2022/0314

Proposal: Erection of outbuilding to rear of dwelling to be used as a store, games area and hobby workshop (Application for a Lawful Development Certificate for a Proposed Development)

Site address: 4 Burton Crescent, Monk Bretton, Barnsley, S71 2QD

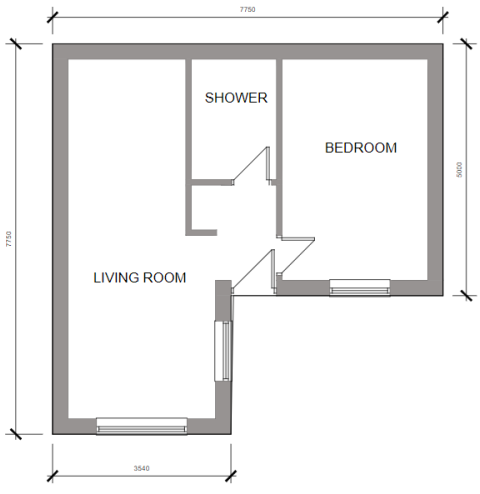
The height measurement needs to be taken from the natural (not artificial or deliberately increased to meet the Class E limitation) land level which immediately abuts the building in question. That natural level is the level that subsisted before work on the building began and the developer can backfill up to that level where this reduces the natural level in carrying out

the development. The “insert” between the building is a new piece of development being added to a building that is partially pre-existing and should be assessed as separate development from the building. The two possibilities are that it falls under Class E which has the raised platform restriction or class F which doesn’t have the raised platform restriction. But either way it represents additional development to the building whose sole purpose is to circumvent the limitation In Class E para E1 (e) (ii). In principle this is not any different from artificially raising the land level adjoining the building to bring it within the limit and is a complete contrivance.

Floor plan with dimensions for new LDC app 2022/0314

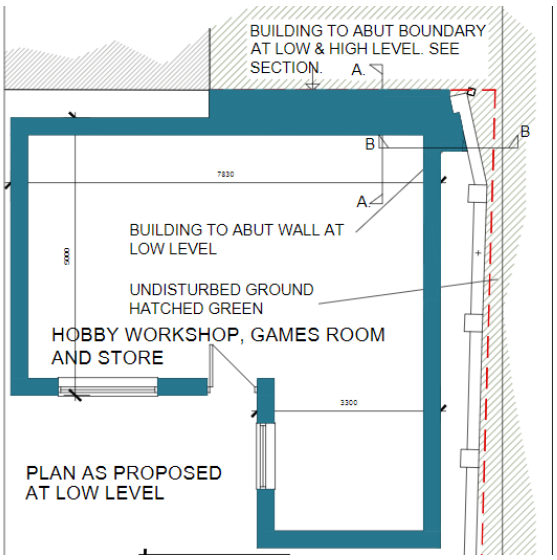
The stated reason for the development was changed from a residential annex to a store, games area and hobby workshop but the amount of floorspace and location have stayed approximately the same throughout on all 5 of the subsequent lawful development certificate applications including this latest proposal as can be seen from the floor plan comparisons below:-

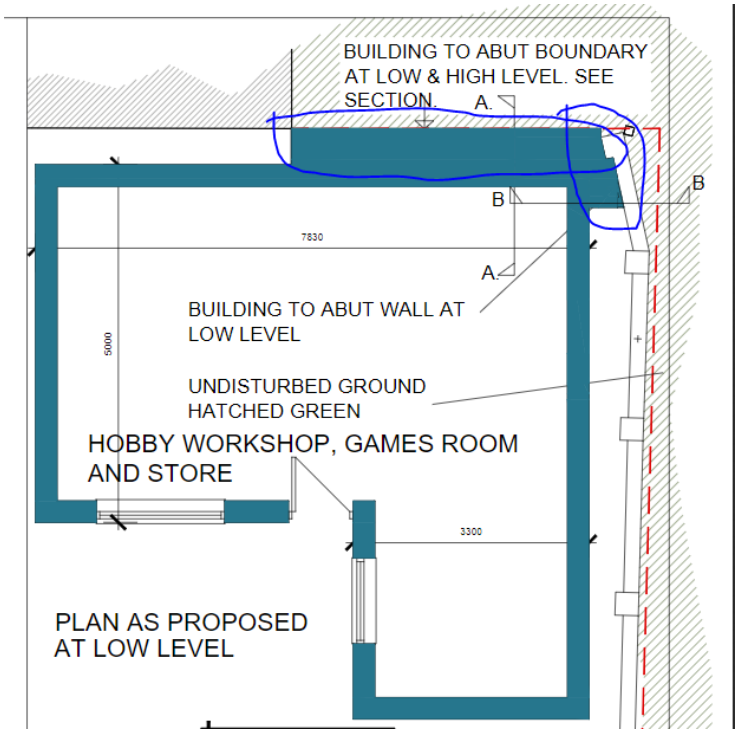
However, with 2021/0220 they disregarded Inspector Braithwaite's determination on the highest pre-existing ground level and sought to argue that the highest pre-existing ground level was 1.238m to enable them to construct a building that would have been 3.738m above the slab (0.79m above the pre-existing ground level established by Inspector Braithwaite). That particular application and appeal was accompanied by a topographical survey. However, the credibility of that topographical data was strongly in question given that it was dated December 2020 which is after Inspector Braithwaite's appeal site visit dated 28 October 2020 and his subsequent decision dated 06 November 2020 and as it ran contrary to his observations. Nor did it tally with the only two photos that exist dating back to before when the works took place in relation to the area of the site in question:-

In addition to that the applicants' topographical claims in the highest pre-existing ground levels have differed on every application they have made: -

- 2020/0110 – 800mm above concrete base
- 2021/0220 – 1.1m above concrete base
- 2021/0415 – 500mm above concrete base
- 2021/0597 – 818mm above concrete base
- 2022/0314 – 818-833mm above concrete base
